UNITED STATES
NUCLEAR REGULATORY COMMISSION
WASHINGTON, D.C. 20555-0001

November 9, 2007

SUBJECT: DECISION ON DIFFERING PROFESSIONAL OPINION APPEAL
INVOLVING RED OIL EVENTS AT THE MIXED-OXIDE FUEL
FABRICATION FACILITY (DPO-2005-002)

Figure 3-1. Calorimetry Data Showing Temperature and Pressure Profile for a Typical Mixture of Tributyl Phosphate and Nitric Acid. The Arrow Shows the Inflection Point in Temperature Prior to the Pressure Spike at 162 Minutes (Rudisill and Crooks, 2001).

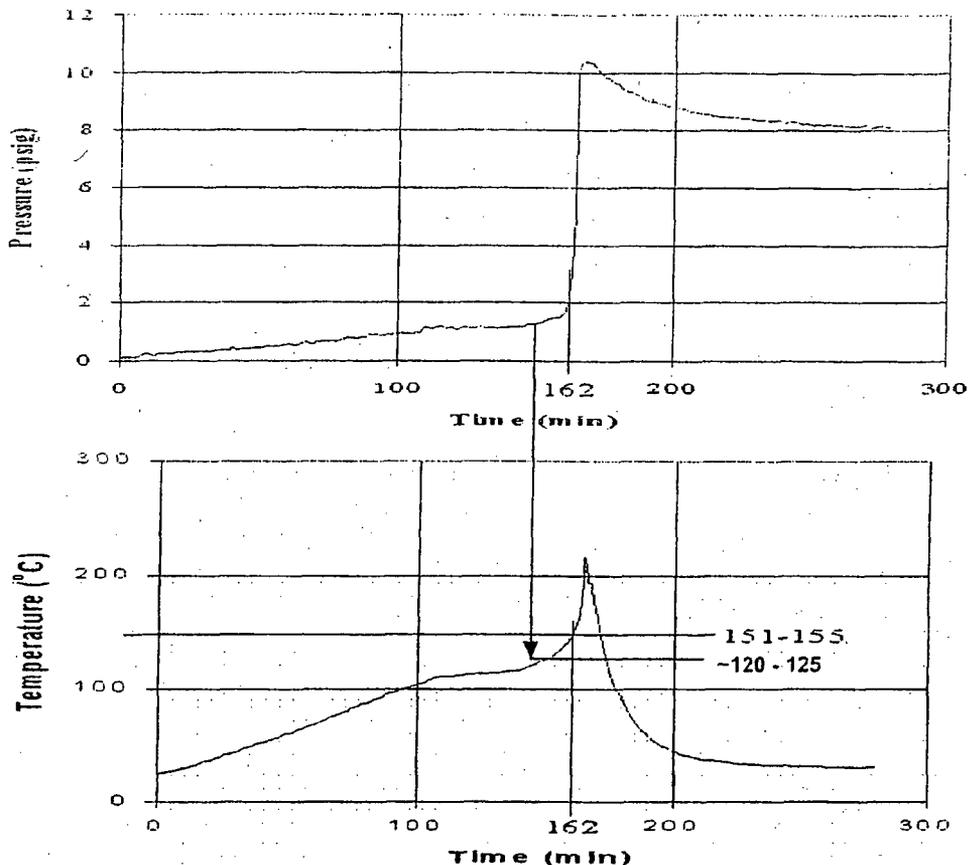
Rudisill and Crooks (2001) examined the red oil runaway reaction temperature. The temperature of runaway reaction was based on the time at which the pressure spike occurred, as shown in Figure 3-1. A detailed examination of the Figure 3-1 indicates that the inflection in temperature (temperature versus time curve) could occur at a much lower temperature {approximately 30 °C [54 °F]} than the pressure spike temperature of 151 °C [304 °F].

Additional tests may be needed to determine the minimum temperature for self-heating. The inflection point indicates a change in the heat generation rate due to self-heating. The temperature at which a pressure spike is observed is indicative of the progression of the red oil runaway reaction. The difference between the temperature at the inflection point and the temperature at which the pressure spike occurs depends on the physical properties of the reactor vessel (e.g., size and insulation). The difference may represent a delay in pressure buildup. If enough time is allowed, the pressure spike may occur at the inflection point. Therefore, the inflection point in the temperature profile where the temperature starts a sharp ascent may be considered as the upper limit beyond which controls would be ineffective, and throttling back to safe condition would be extremely difficult. Paddleford and Fauske (1994) observed the initiation of self-heating in a closed system at 116 °C [241 °F], which supports the
